WCAP-17788-NP, Revision 0
Project Number 99902037

OG-18-112

Subject: PWR Owners Group
**Clarifications for WCAP-17788 Volume 5 NRC RAI Responses Related to
PWROG Comprehensive Analysis and Test Program for GSI-191 Closure**

**RT-LTR-18-79, Rev. 0
Attachment 2**

Table 1: Summary of Actual Maximum Test Conditions

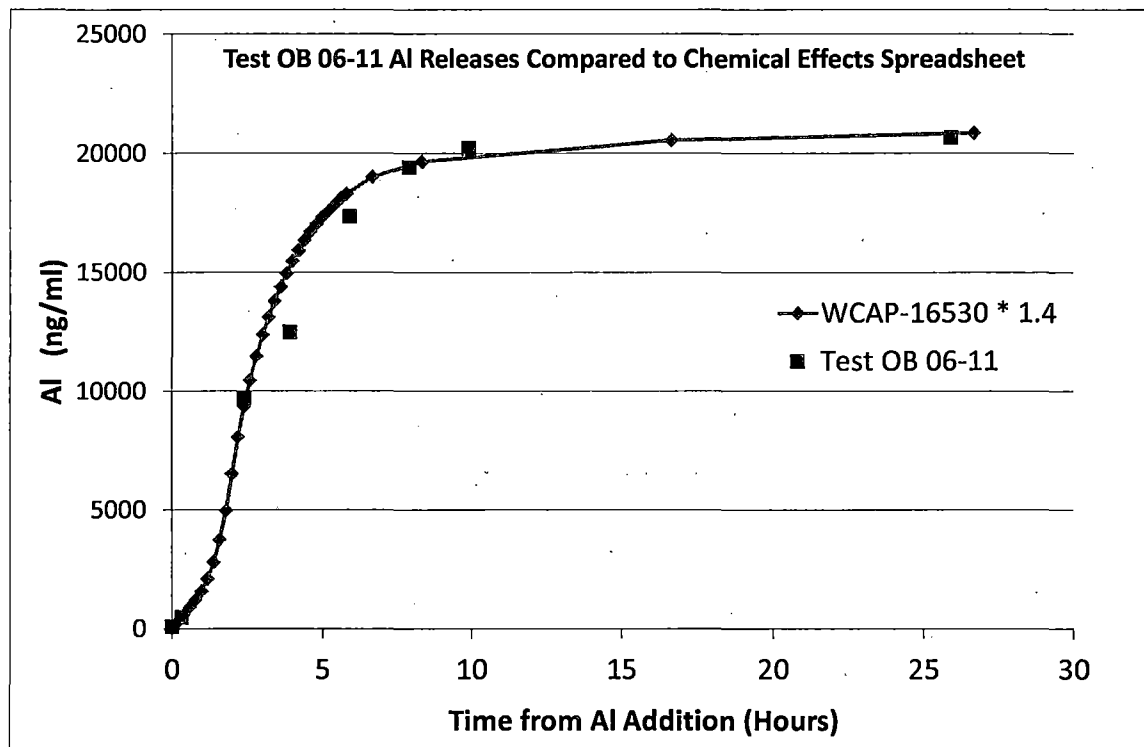
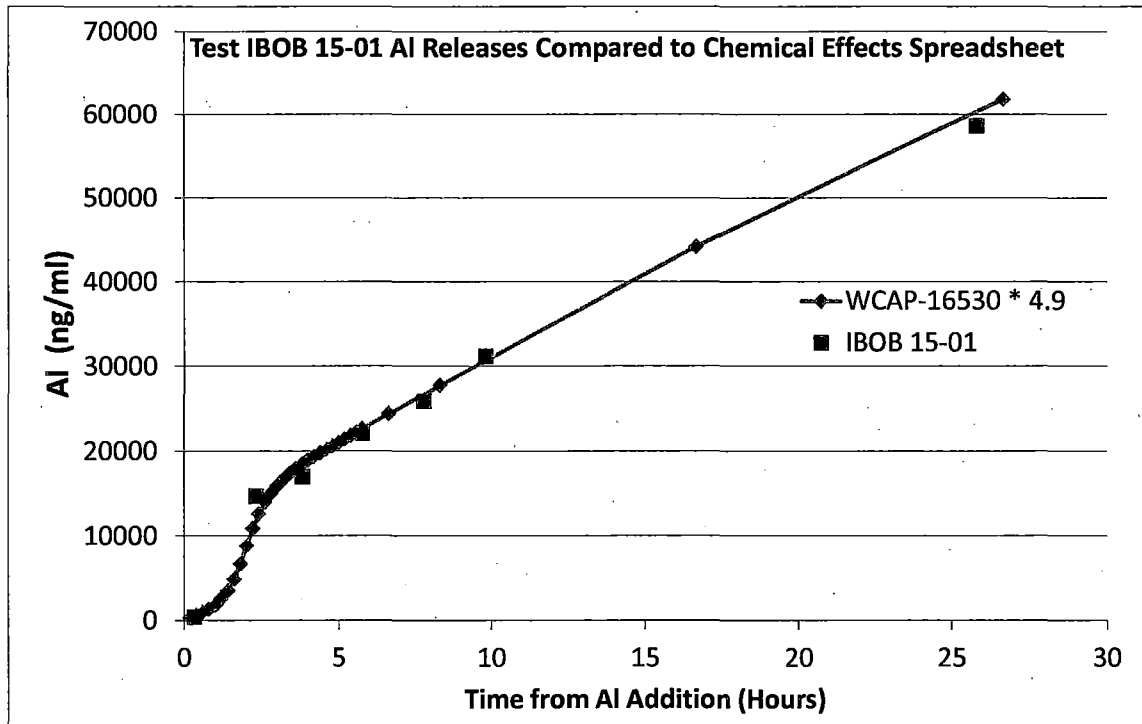
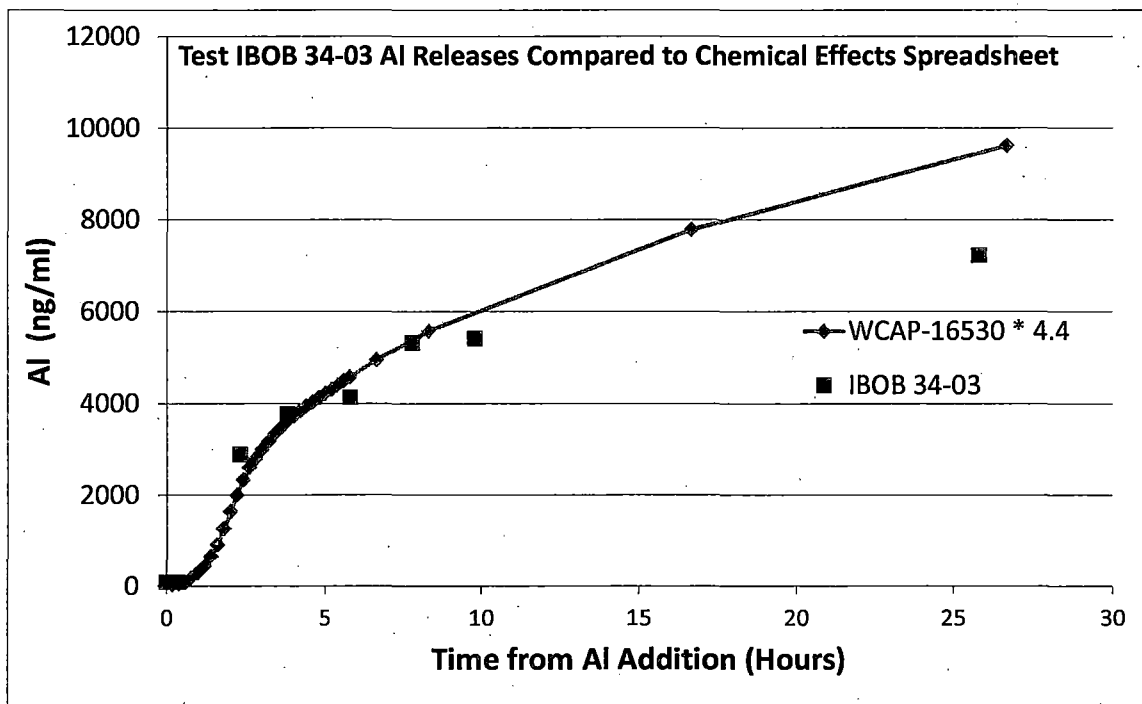
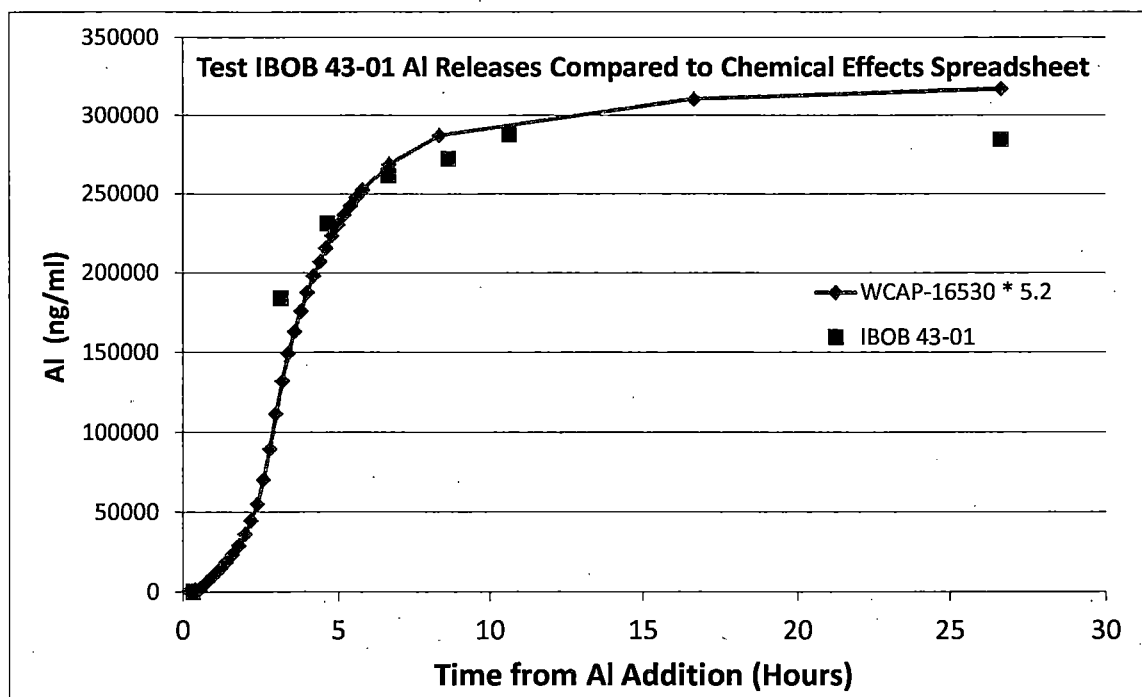
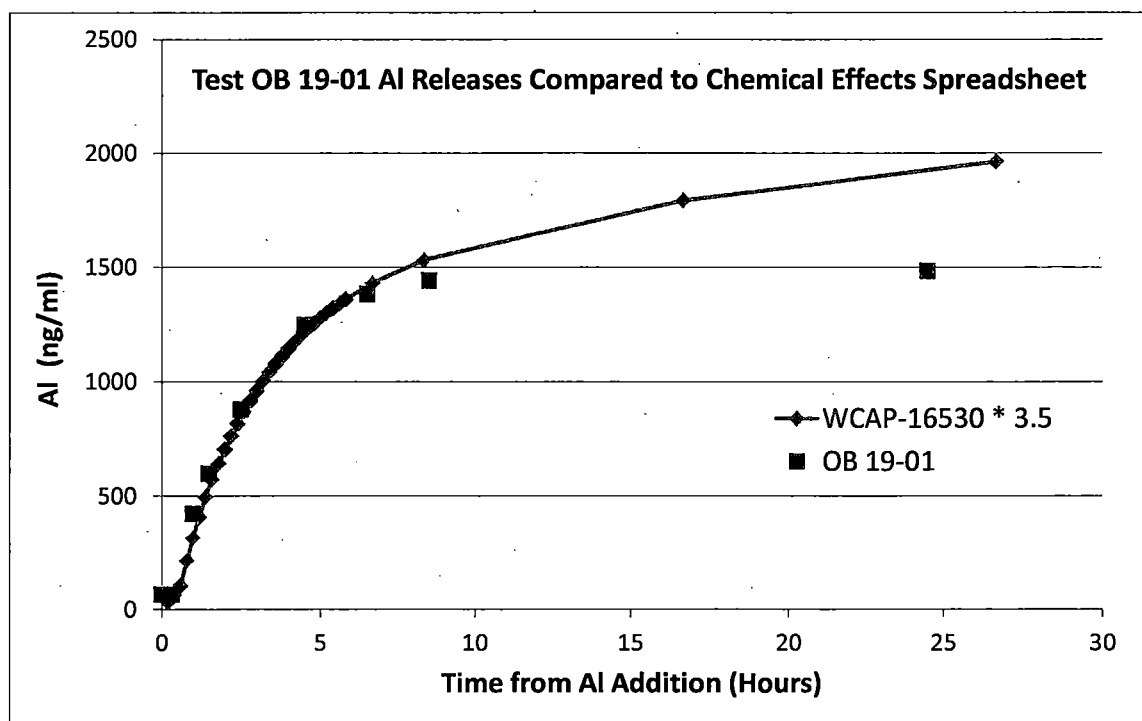
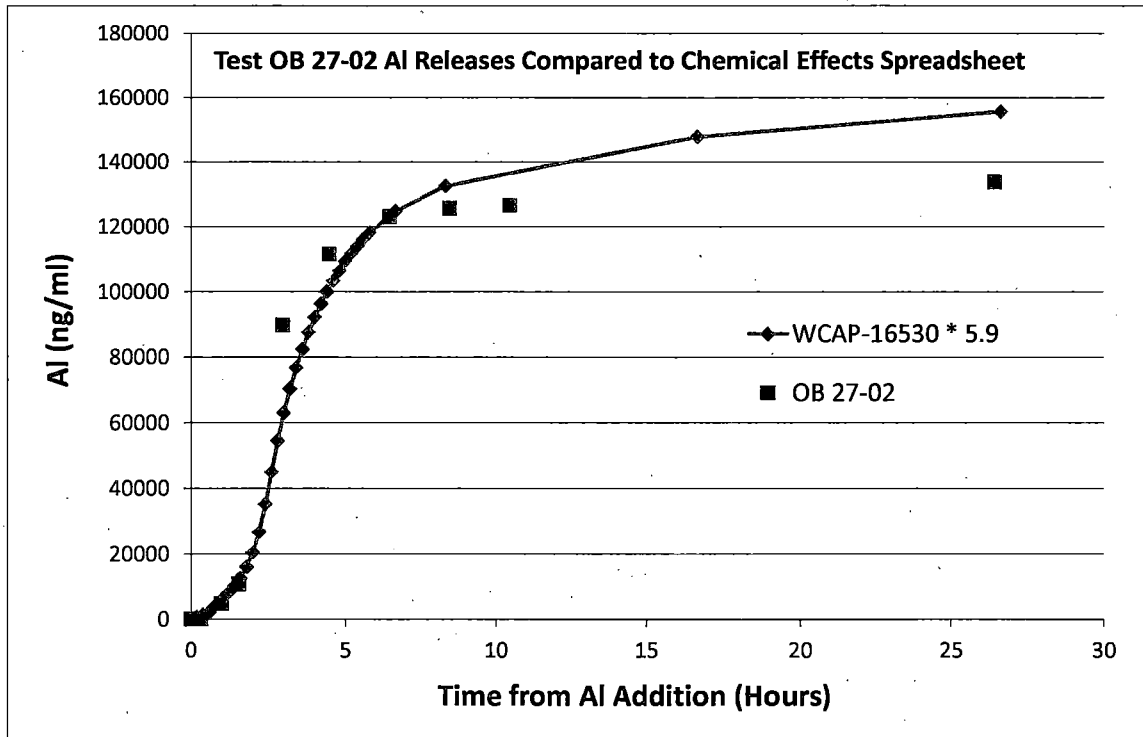
A factor of 12x WCAP aluminum release was used to bound the experimental data. Can you provide insight on how much did the WCAP-16530-NP aluminum release under-predicted the autoclave experimental data on average for the different buffers?

Several plants were evaluated to compare the aluminum release predicted by GSI-191 Chemical Effects model (Chemical_Effects.xls Version 1.1) documented in WCAP-16530-NP-A (Reference 3) to the results of the chemical effects testing (Reference 2). Two plants were selected for each of the three buffer chemicals, sodium hydroxide (NaOH), trisodium phosphate (TSP), and sodium tetraborate (NaTB), for a total of six plants. Plants were selected that were close to the group average for the maximum target pH (8.6) and temperature (254°F). Table 1 lists the test runs that were chosen to model, along with the actual maximum pH and temperature.

For each test run, a correction factor was applied to the results of the Chemical Effects model to bound the experimental data at the 6 hour mark. These results are shown in Table 1 and Figure 1 through Figure 6. The Chemical Effects model under-predicted the test data on average by a factor of 4.2, with an overall range of 1.4 to 5.9.

**Figure 8: Test 40-01 Autoclave Temperature Curve**

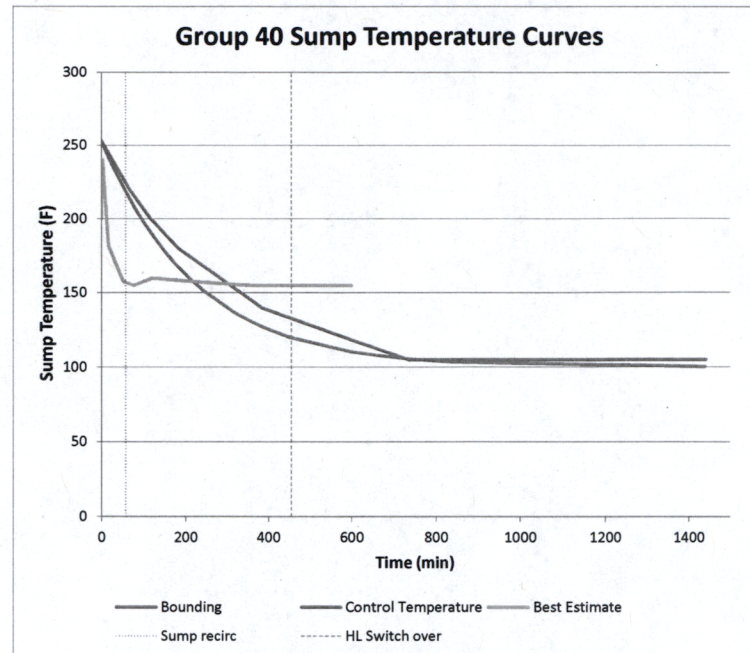
Page 8 states with respect to the default function cooling curves, "the effect of the faster cooling rate is not known, but the unquantified conservatism of using a maximum sump temperature, extra corrosion generated during the autoclave heat-up, and sample cooling before filtration will still lead to a conservative result." Please pick a representative case and quantify the impact of each of these three items. For maximum sump temperature, a comparison could be made with a best estimate maximum post-LOCA temperature.

The actual temperature recorded in the autoclave test for Group 40 is shown in Figure 8. The temperature profile included a soak time of 30 minutes at 200°F, and then a temperature ramp to the maximum temperature that took 83 minutes. Thus, aluminum was corroding for a period of 113 minutes before the maximum temperature was reached and the bounding temperature curve was followed.

Figure 12: Group 18 Precipitation Risk using Oven Hold Temperatures to Calculate Precipitation Boundary

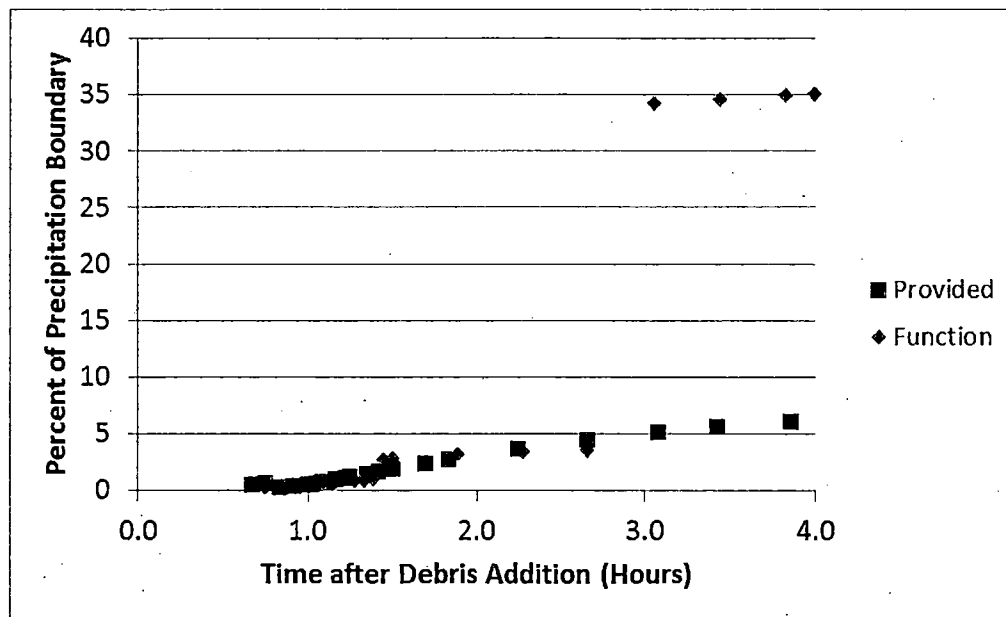
Figure RAI-5.1-13 shows a plot of the percent of the precipitation boundary for Group 18 that used actual temperatures since the minimum temperature reached was already close to the ultimate sink temperature. How do the "provided" and "function" plots compare if instead of using the actual temperatures the temperature plotted is the oven hold temperature prior to hot filtration (per the Appendix E procedure)?

The plot shown below in Figure 12 was generated using the oven hold temperatures to calculate the precipitation boundary for both the temperature profile "Provided" by the Group 18 utility and the profile generated using the temperature "Function" described in Section 3 of WCAP-17788-P/NP Volume 5 (Reference 2).

The precipitation risks are quite similar for the Provided and the Function curves until just after 3 hours, when the Function sump temperature drops below 150°F. At this point, the sample hold temperature jumps from 120°F to 70°F, causing the step increase in precipitation risk. The Provided temperature curve does not go below 150°F, so the large increase in the precipitation risk is not observed. In conclusion, the Function temperature profile produces roughly the same precipitation risk as the Provided temperature profile at short times, and is conservative at longer times.

Figure 13: Scanning Electron Micrograph of CalSil Powder Particle

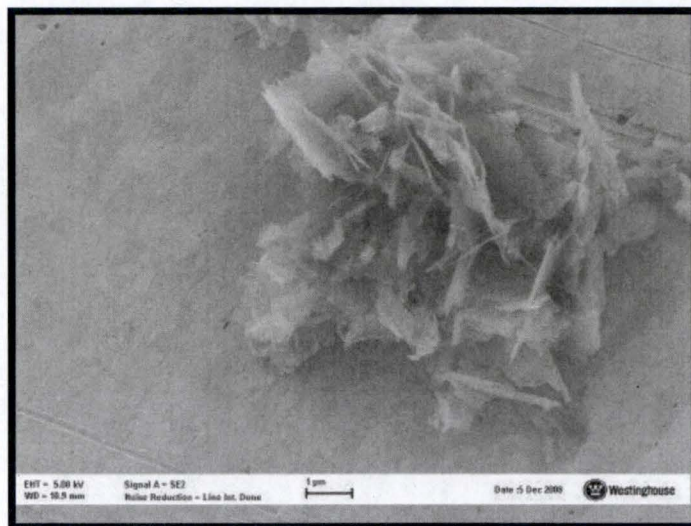
For the IBOB and OB TSP tests with calcium silicate, was all the calcium silicate crushed? If it was added in pieces, what was the size of the pieces? How was it determined that a longer drain time was physical debris rather than chemical precipitate?

The differences in dissolution rates for different varieties of CalSil, Microtherm, Min-K, and Fiberglass insulation will be largely a function of how much insulation surface area is exposed to coolant flow. The Microtherm and CalSil that were used in this testing were both fine powders, as had been used in the WCAP-16530-NP-A testing (Reference 3). Photographs of the debris material can be found there. SEM images of typical CalSil and Microtherm particles are shown in Figure 13 and Figure 14, respectively. The particles were often held together in clumps by the insulation fiber content, but the clumps were loose and dispersed well in the autoclave out-of-bag testing. The fiberglass and mineral wool and aluminum silicate insulation materials were shredded before use and were observed to disperse within the autoclaves. The concrete was crushed to a powder. By using the debris materials in a highly dispersed state in the out-of-bag testing, one extreme for exposed insulation surface area was tested. For the in-bag testing, the insulation was held within a small volume, representing an accident scenario where insulation was wetted but not severely damaged. Thus, the testing covered a wide range of debris dispersion and dissolution rates.
